Access Compliance Report

Public Rights-of-Way

(Curb Ramps)

Intersection ID: 10734	Main Street: DUNLOE_ST	Cross Street: SYLVANIA_AV	Location: E
ADA ID: 5106F529F85C	Ramp Type: Perp	Initial Pass/Fail: Fail	Overall Compliance: No
Severity Score: 1.25			
Codes/Mitigation Info/Possible Solution		Field Measurements/Component Compliance

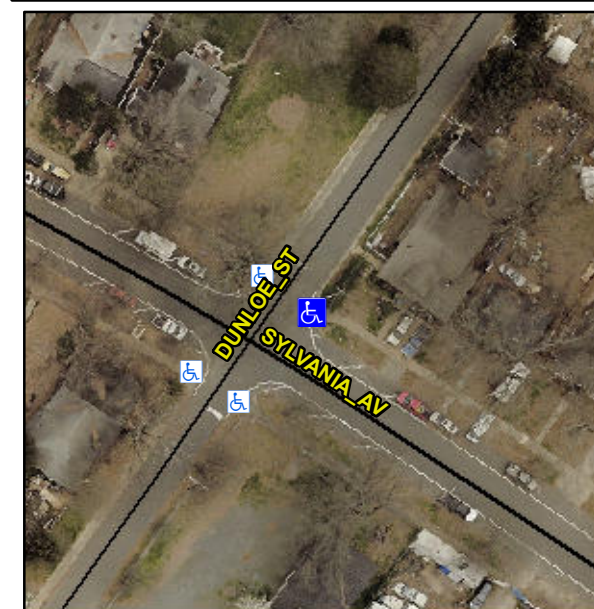
Not Found, R304.5.3

Compliance	Description	Data	Compliance	Description	Data
N/A	Ramp Length (in)	25.0	Yes	Ramp Slope (%)	6.7
Yes	Ramp Width (in)	48.0	No	Ramp XSlope (%)	2.9
N/A	Flare Type LT	N/A	N/A	Flare Type RT	N/A
N/A	Flare Slope LT (%)	N/A	N/A	Flare Slope RT (%)	N/A
N/A	Flare Traversable LT?	N/A	N/A	Flare Traversable RT?	N/A
N/A	Landing Length (in)	N/A	N/A	DWS Provided?	N/A
N/A	Landing Width (in)	N/A	N/A	DWS Contrast?	N/A
N/A	Landing Slope (%)	N/A	N/A	DWS Length (in)	N/A
N/A	Landing X Slope (%)	N/A	N/A	DWS Full Width?	N/A
N/A	Landing Curb? (Y/N)	N/A	N/A	DWS Offset (in)	N/A
N/A	Shared Landing?	N/A			
N/A	Gutter Ponding?	N/A	N/A	Gutter Slope (%)	N/A
N/A	Gutter Lip Ht (in)	1.5	N/A	Gutter X Slope (%)	N/A
N/A	Painted X Walk1?	No	N/A	Painted X Walk2?	N/A
	X Walk 1 Direction	To NW		X Walk 2 Direction	N/A
N/A	X Walk 1 Width (in)	N/A	N/A	X Walk 2 Width (in)	N/A
	X Walk 1 Slope (%)	4.5		X Walk 2 Slope (%)	N/A
	X Walk 1 X Slope (%)	3.0		X Walk 2 X Slope (%)	N/A

Remove & Replace Entire Ramp.
